ECE/TRANS/WP.29/2008/17
13 December 2007

Proposal for Supplement 31 to the 03 series of amendments to the Regulation No. 37
(Filament lamps of power-driven vehicles and their trailers)

Submitted by the Working Party on Lighting and Light-Signalling (GRE) */

" CATEGORY H15 Sheet H15/1

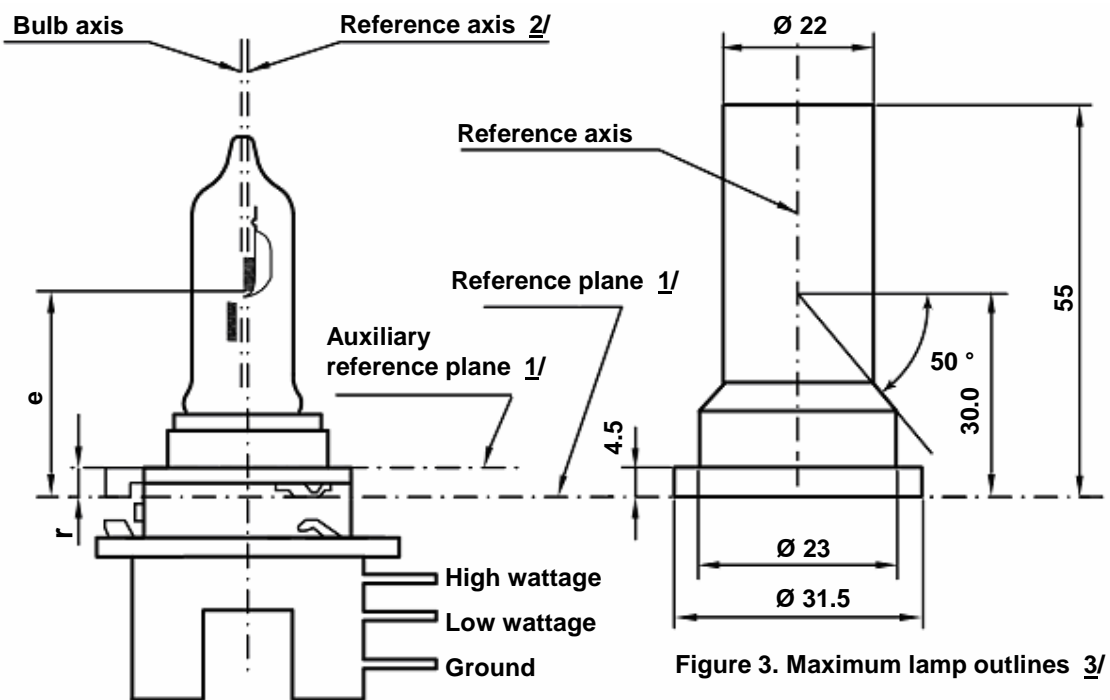
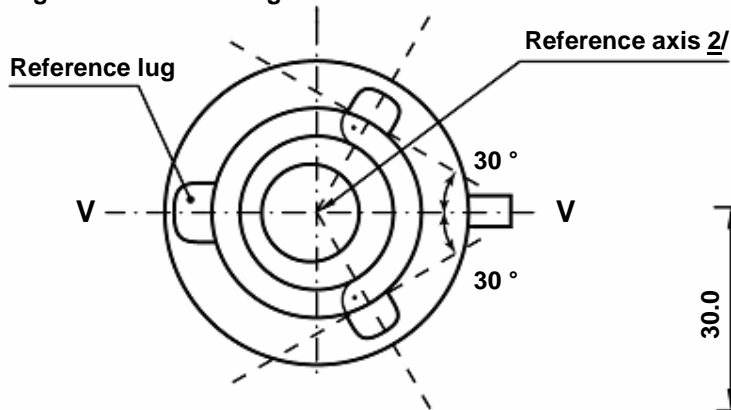
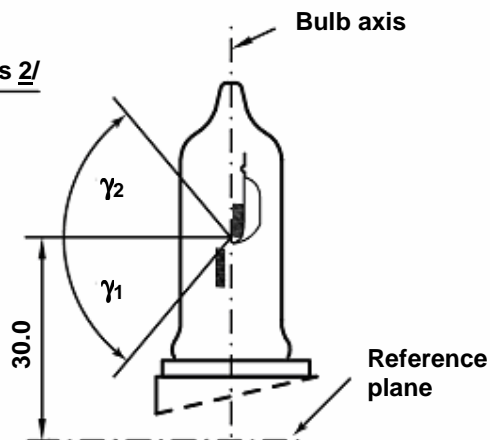
Sheets H15/1 to 5, amend to read:

- 1/ The reference plane is defined by the points at which the holder touches the three lugs of the cap ring from the plug side. It is intended for use as an internal reference plane.
The auxiliary reference plane is defined by the points on the surface of the holder on which the three supporting bosses of the cap ring will rest. It is intended for use as an external reference plane.
The Cap is designed for use of the (internal) reference plane, but for certain applications the (external) auxiliary reference plane may be used instead.

- 2/ The reference axis is perpendicular to the reference plane and crosses the intersection of the two perpendiculars as indicated in figure 2 on sheet H15/1.

- 3/ Glass bulb and supports shall not exceed the envelope as indicated in figure 3. The envelope is concentric to the reference axis.
- 4/ Glass bulb shall be optically distortion free within the angles γ_1 and γ_2 as indicated in figure 4. This requirement applies to the whole bulb circumference within the angles γ_1 and γ_2 .

Sheet H15/2

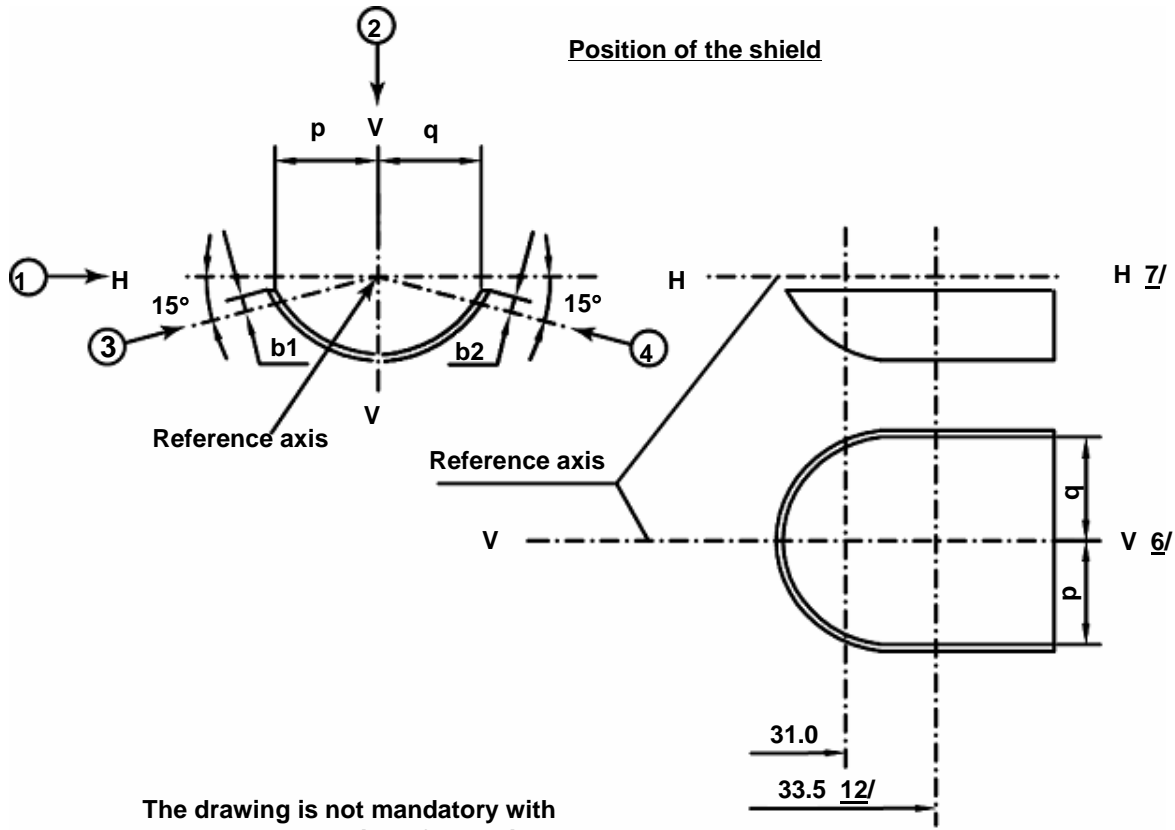
Dimensions in mm		Filament lamps of normal production				Standard filament lamp	
		12 V		24 V		12V	
e		30.0 +0.35/-0.25		30.0 +0.35/-0.25		30.0 +0.20/-0.15	
γ_1		50°min		50°min		50°min	
γ_2		50°min		50°min		50°min	
r	For details see cap sheet						
Cap PGJ23t-1 in accordance with IEC Publication 60061 (sheet 7004-155-1)							
ELECTRICAL AND PHOTOMETRIC CHARACTERISTICS							
Rated values	Volts	12 <u>5/</u>		24 <u>5/</u>		12 <u>5/</u>	
	Watts	15	55	20	60	15	55
Test voltage	Volts	13.2		28.0		13.2	13.2
Objective values	Watts	19 max.	64 max.	24 max.	73 max.	19 max.	64 max.
	Luminous flux	260	1,350	300	1,500		
		± 10%					
Reference luminous flux at approximately 12 V						1,000	
Reference luminous flux at approximately 13.2 V						1,350	
Reference luminous flux at approximately 13.5 V						290

- 5/ The values indicated in the left-hand columns relate to the low wattage filament. Those indicated in the right-hand columns relate to the high wattage filament.

Additional explanations to sheet H15/3

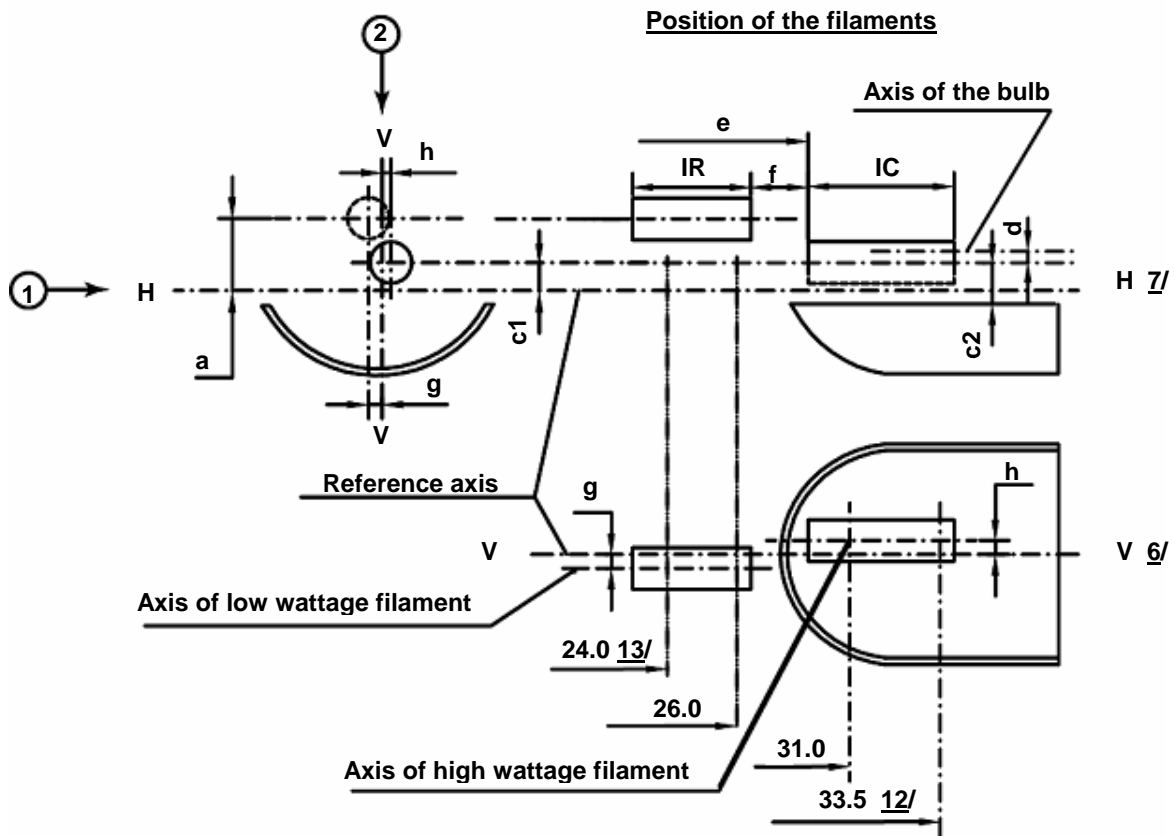
The dimensions below are measured in four directions:

- 1) for dimensions a, c1, c2, d, e, f, IR and IC;
- 2) for dimensions g, h, p and q;
- 3) for dimension b1;
- 4) for dimension b2.

Dimensions b1, b2, c1 and h are measured in planes parallel to the reference plane at distances of 31.0 mm and 33.5 mm (34.0 mm for 24 V types).

Dimensions c2, p and q are measured in a plane parallel to the reference plane at a distance of 33.5 mm (34.0 mm for 24 V types).

Dimensions a and g are measured in planes parallel to the reference plane at distances of 24.0 mm (24.5 mm for 24 V types) and 26.0 mm."
